Subject: 2010 Edition, Part 2, Supplement 2, S2.10.2 – Define Deteriorated Rivet Heads

File Number: NB11-1603

Proposal: Update text in S2.10.2 to include guidelines for decayed rivets.

Figure S2.10.2

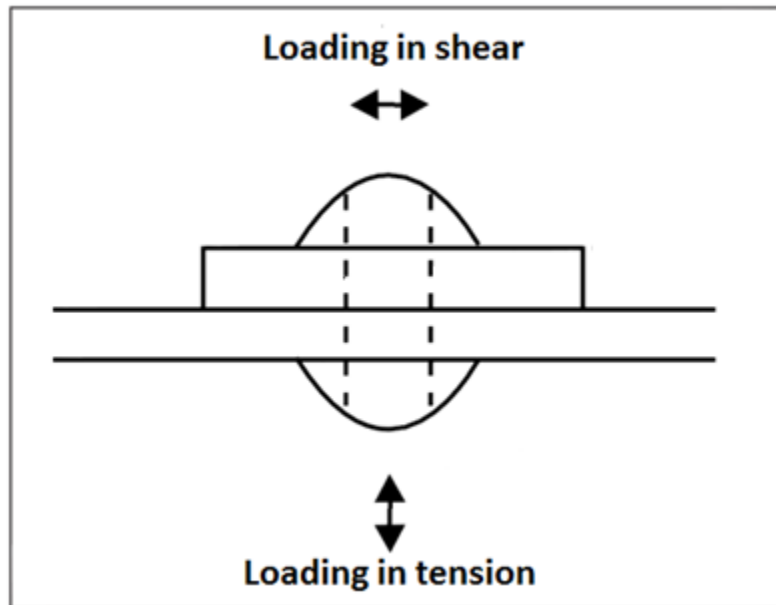
- a. Visually identify all connections containing rivets which show signs of significant corrosion.
- b. Categorize each connection as the type which loads the rivets in one of three possible modes (pure shear, pure tension, or combined shear and tension). Refer to Figure S2.10.2.

- ii. NBIC Part 3, S2.13.13 defines procedures to address a leak around a rivet head.
- d. Allowable corrosion:
 - i. For rivets in pure shear load, the amount of measured head deterioration shall not exceed 80% of its total head volume. Where rivets have countersunk heads, the head diameter must be equal or greater than 65% of the original head diameter. Severe head corrosion will require further evaluation of the condition and thickness of the plate at the joint.

- ii. For rivets in pure tension, the amount of measured head deterioration shall not exceed 35% of its total head volume. Where rivets have countersunk heads, the head diameter must be equal or greater than 85% of original head diameter. Application of this value shall take into consideration the consistency and frequency of adjacent rivets showing excessive corrosion.

- iii. For connections subjected to combined shear and tension loads, the amount of measured head deterioration shall not exceed 60% of its total head volume. Where rivets have countersunk heads, the head diameter must be equal or greater than 75% of original head diameter. Application of this value shall take into consideration the consistency and frequency of adjacent rivets showing excessive corrosion.

Figure 12 - Max. Stress Vs. Loss of Head Volume (Uniform Model)

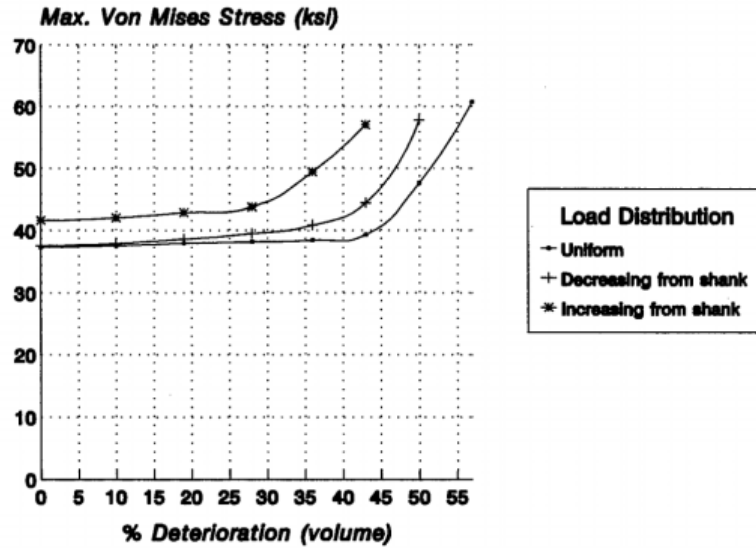
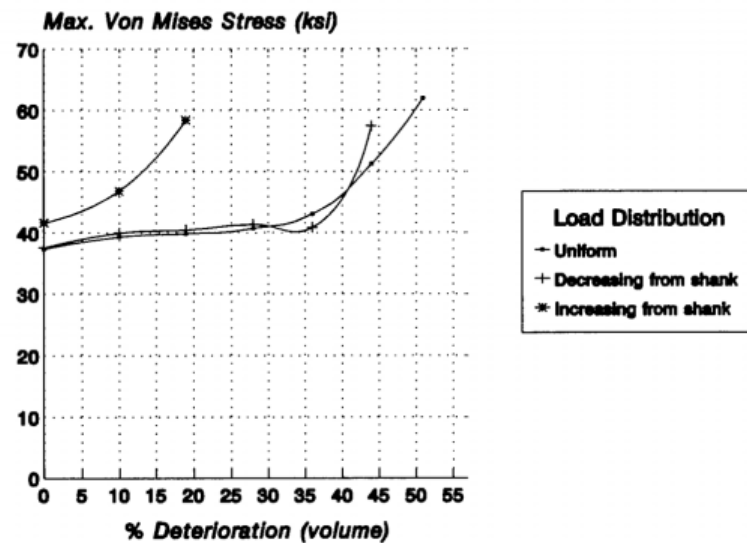
[2] performs FEA on a 7/8” button head rivet, and recommends that the measured amount of head deterioration shall not exceed 35% of its total head volume.

The FEA results [2] assumed even corrosion around the entire rivet head. These conclusions (35% volume removal) are similar to the rule-of-thumb U.S. Navy guidelines [1, 9] (31.5%) when corrosion is maximum at the crown of the rivet head. Given this consistency, this draft targets a maximum 35% volume removal threshold for rivets in pure tension.

Deteriorated Button Head Rivet Dimensions

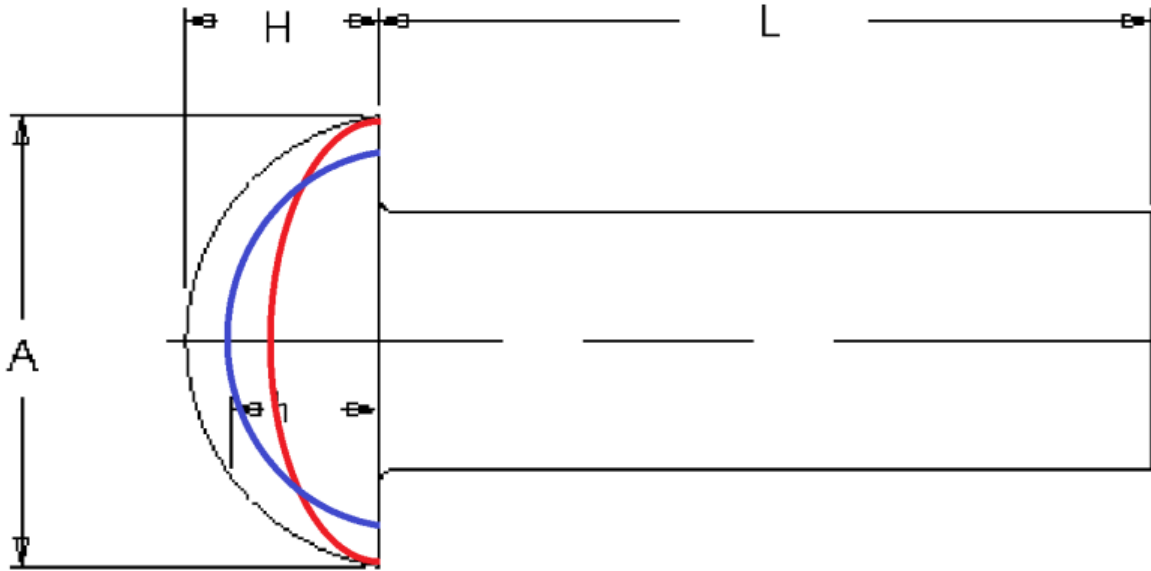
We will consider two types of generalized deterioration. All red values will represent even deterioration at the crown of the head, where the base of the rivet head remains intact. All blue values represent equal deterioration around the rivet head.

Assuming even deterioration at the rivet head crown, but no deterioration at the edge of the rivet head (red line), **60%** of rivet head material is removed before the rivet must be replaced.

Assuming even deterioration (blue line) throughout the rivet head, **52.5%** of material is removed before the rivet must be replaced.

Assuming even deterioration at the rivet head crown, but no deterioration at the edge of the rivet head (red line), **31.5%** of rivet head material is removed before the rivet must be replaced.

Assuming even deterioration throughout the rivet head, **55%** of material is removed before the rivet must be replaced.

US Army [2]: minimum head volume = $0.65 * \text{original head volume}$

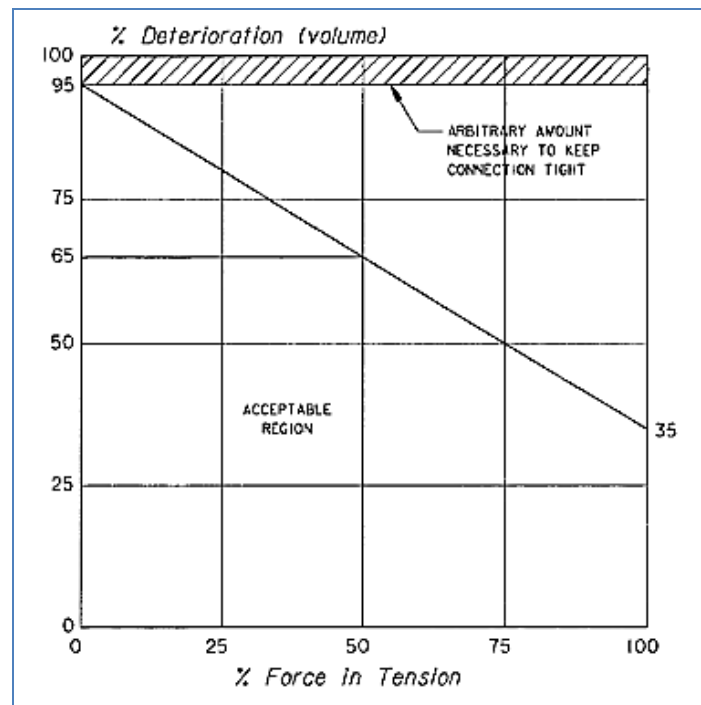
Assuming even deterioration at the rivet head crown, but no deterioration at the edge of the rivet head (red line), to obtain 35% removal of head volume, 'h' must only reduce by **20%** of its original height. Using NBIC S1.4.2.1 metrics, 'h' must be **40%** or greater than shank diameter.

Assuming even deterioration throughout the rivet head, to obtain **35%** removal of head volume, 'h' must only reduce by **17.5%** of its original height. Using NBIC S1.4.2.1 metrics, 'h' must be **46%** or greater than shank diameter.

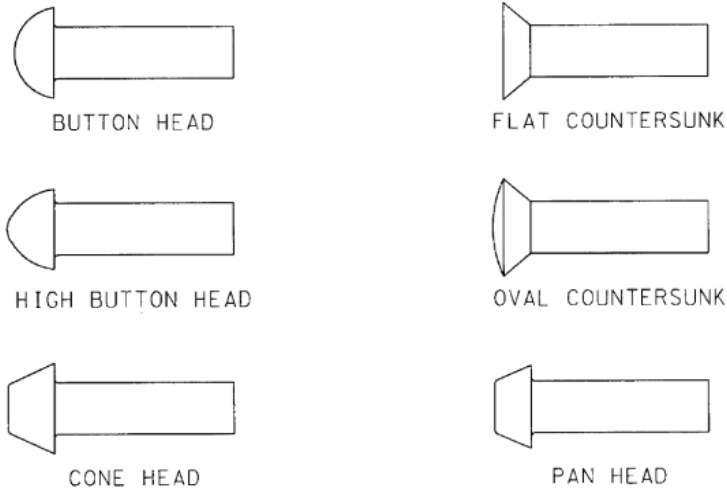
[2] also suggested that for rivets in pure shear, rivets do not need to be replaced as long as the corrosion has not extended into the shank and that the rivet is not loose. Furthermore, the ratio of total head volume removed may linearly scale from 35% (for 100% tension) to 95% (for 100% shear). Refer to below figure from [2].

adopts the rule to apply equal 50/50% shear/tension. Given the above text, allowable head corrosion for rivets in combined shear/tension is 60%; consistent with NBIC S1.4.2.1.
